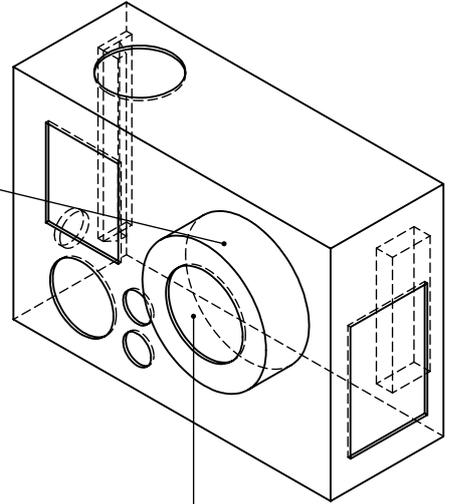
4 additional holes for lens protector???

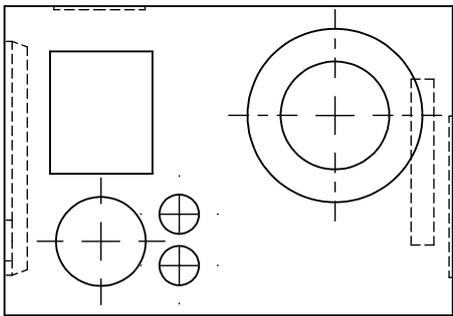
0.5mm extruded to outside in middle

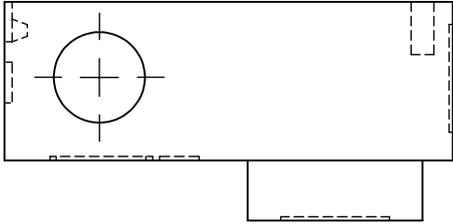
Additional 1.8mm width spacer below (for nail)
